**Monash Planning Scheme Amendment C167mona  
Mount Waverley Major Activity Centre**

**Panel Report**

**25 January 2024**

**Figure 4 Mount Waverley Major Activity Centre Built Form Plan**

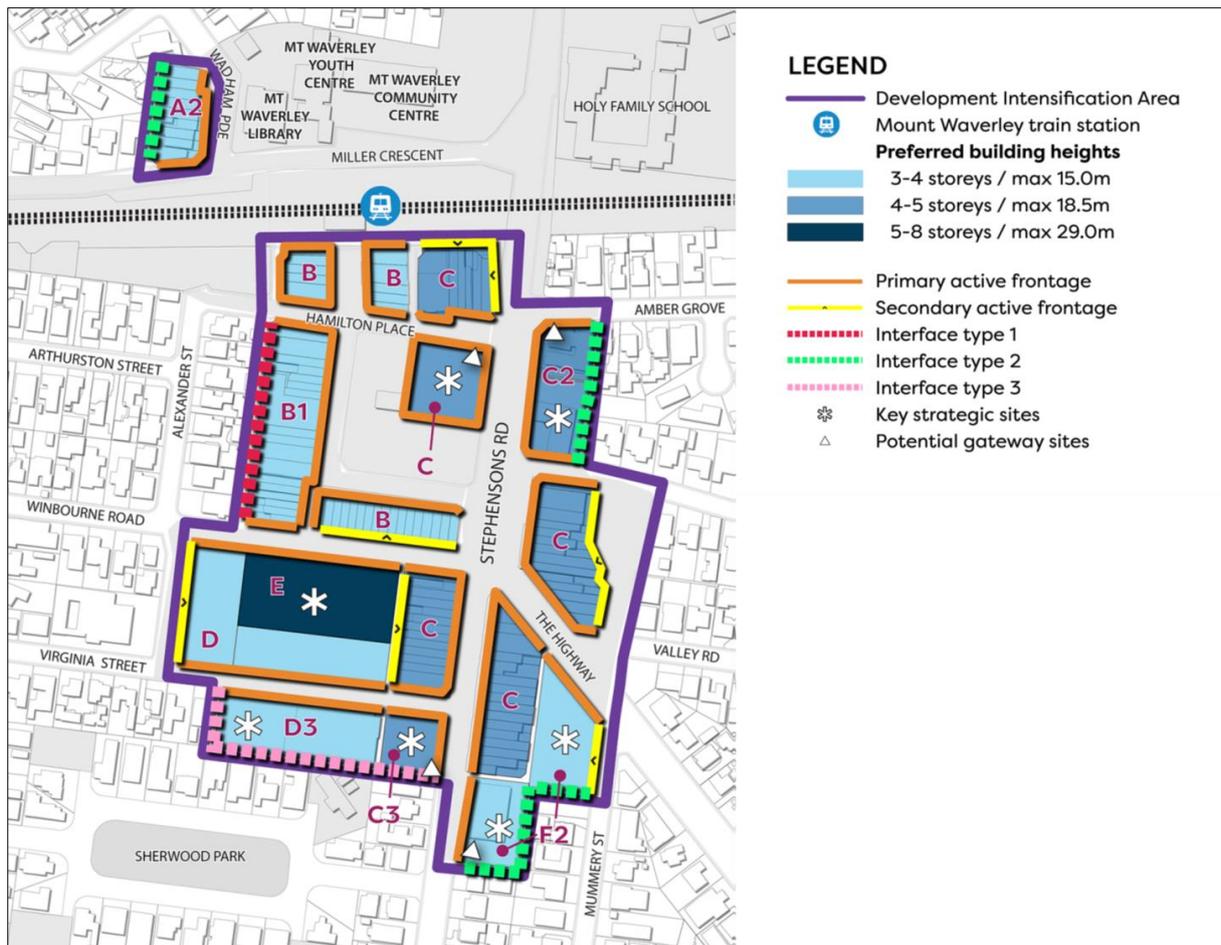
- make building heights mandatory rather than discretionary
- decrease the preferred height 256 Stephenson Road (shown as C2 on Figure 4) from 5 storeys to 3-4 storeys, consistent with other properties with a residential interface
- decrease overall building heights proposed, generally to 3 to 4 storeys
- increase the preferred height of the DJLI property from 4 to 5 storeys to 8 storeys.

- is identified as a gateway site
  - not adjacent to sensitive interfaces, being bound by roads and carpark on all sides
- a 5-8 storey and 29 metre preferred maximum height would better respond to the attributes of the DJLI property and would be consistent with the heights originally proposed for the site in the Draft Mount Waverley Structure Plan

- c) **revise Figure 1 (Built form map) to:**
    - **increase the preferred height for land at 275-283 Stephenson's Road, Mount Waverley (labelled as C4) from 18.5 metres to 29 metres**

**Amend Design and Development Overlay Schedule 17 as shown in the Panel preferred version in Appendix D:2 to revise Table 1 (Preferred maximum building heights) and Figure 1 (Built form map) to increase the preferred height for land at 275-283 Stephensons Road, Mount Waverley (labelled as C4) from 18.5 metres to 29 metres.**

**Figure 8** Sheppard recommended changes to active frontage

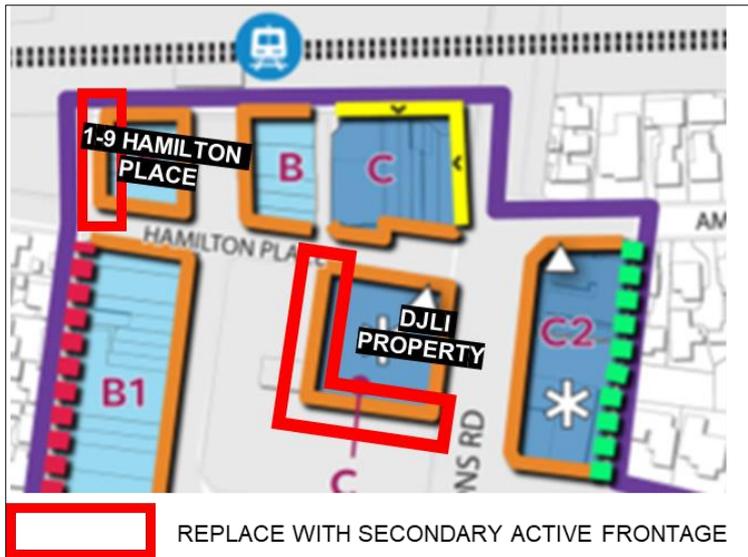
- the DJLI property and the block created by 1-9 Hamilton Place are entirely edged with ‘primary active frontage’
- this is unfeasible as retail uses necessarily have back of house functions such as loading and storage
- the function design of larger floorplate retail uses (such as supermarkets) preclude activation of 100 percent of their shopfloor edges.

Mr Sheppard recommended DDO17 Figure 1 be amended to change the car park edges of the DJLI property to secondary active frontages. He noted a similar change may be appropriate for the western edge of the block comprising 1-9 Hamilton Place.

Council's approach does not assist proponents and decision makers decide where an active frontage should be prioritised. In the Panel's view, the designation of 'active frontages' should be informed by the Public Places Plan (Figure 6) and Movement and Access Plan (Figure 7). On this basis the 'primary active frontage' designation should be removed from the west boundary of the DJLI property and the west boundary of properties at 1-9 Hamilton Place.

- a) **delete the 'primary active frontage' on Figure 1 from the west boundary of 275-283 Stephensons Road and 1-9 Hamilton Place**
- b) **replace the primary and secondary active frontage requirements in Clause 2.0 with "*Development should maximise use of clear glazing at ground level adjacent to a primary active frontage on Figure 1. Development should use clear glazing at ground level adjacent to a secondary active frontage on Figure 1*".**

**Figure 2 - Viewlines from Sherwood Road Reserve**

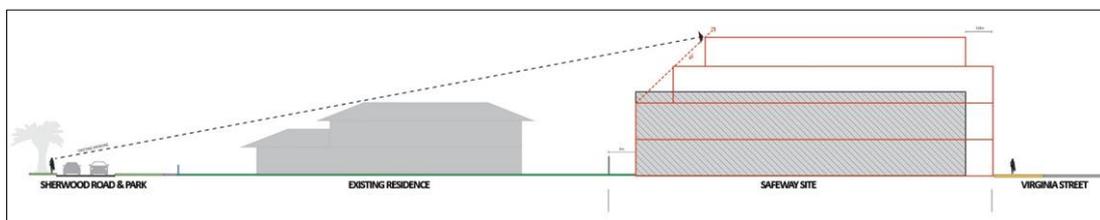
In oral evidence, Mr Biles stated retaining Figure 2 in DDO17 helps bring attention to the need to achieve a “*well considered architectural response*” to buildings that can be viewed from Sherwood Road Park.

**Figure 9** Negri recommended changes to interface types

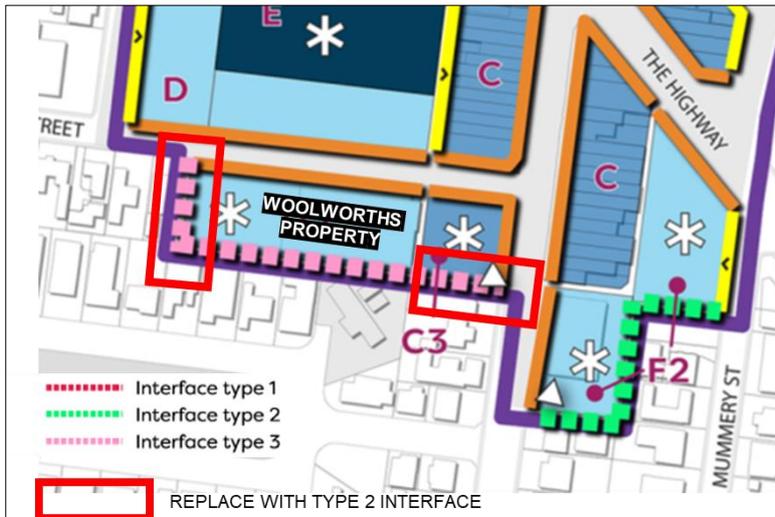
However, Mr Negri considered the Type 3 Interface was not warranted along the western boundary of the Woolworths southern property and the south side of the Council car park fronting Stephenson's Road (Site C3 on Figure 9) because these boundaries do not adjoin properties in Sherwood Road. Mr Negri recommended the Type 2 Interface be applied in these locations. Woolworths supported Mr Negri's recommendation.

Council did not support Mr Negri’s recommendation, and noted the proposed ground and upper level setbacks will ensure that building form is articulated to provide visual interest and maintain the human scale of the MWMAC.

- **replace the Type 3 Interface with Type 2 Interface on the (i) western boundary of the Woolworths southern property at 64-74 Virginia Street and (ii) southern boundary of the land at 331-343 Stephenson's Road**

The Panel agrees with Woolworths that the Type 3 Interface is directed at managing the visual impact of development when viewed from Sherwood Park and Sherwood Road. It is not warranted in the areas identified by Mr Negri (Figure 9). The Type 2 Interface should be applied to these areas, consistent with approach taken to sites A2 and F2 shown on Figure 4, which similarly abut residential properties.

**Figure 10 Mount Waverley Structure Plan Key Policies and Actions**

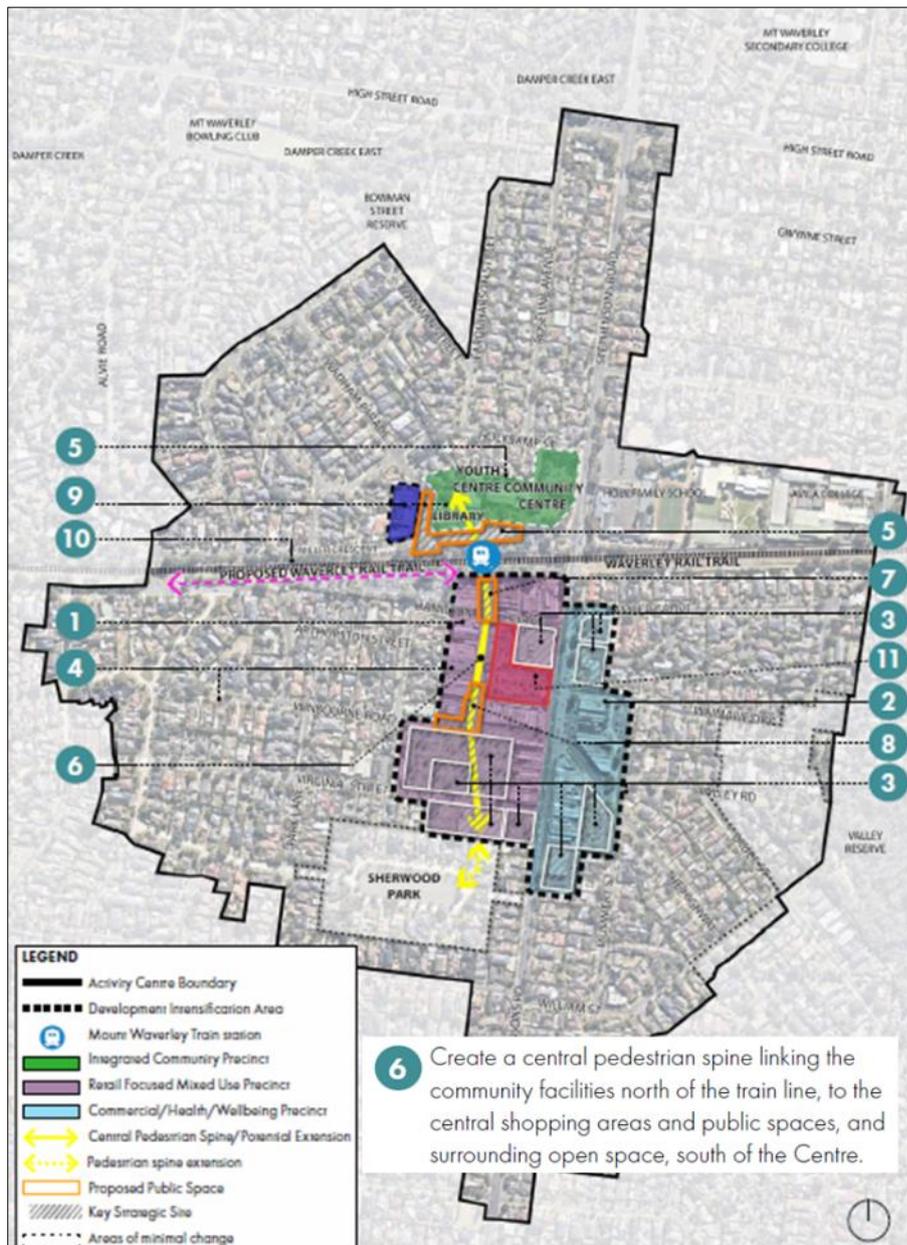
The central pedestrian spine forms part of the principal pedestrian network identified on the Movement and Access Plan (Figure 7). The Panel agrees with Mr Biles that the central pedestrian spine is a key element of the Structure Plan. It should inform the built form response to various detailed design issues, including active frontages and solar access to public spaces.

- **show public spaces and the principal pedestrian network (or insert a new map)**
    - **show the central pedestrian spine between the Mount Waverley Train Station and Winbourne Road as part of the principal pedestrian network**

- **show that part of the central pedestrian spine between Winbourne Road and Virginia Street as 'indicative – final alignment to be determined'**
    - **delete the 'primary active frontage' from the western boundary of 275-283 Stephenson's Road and 1-9 Hamilton Place**
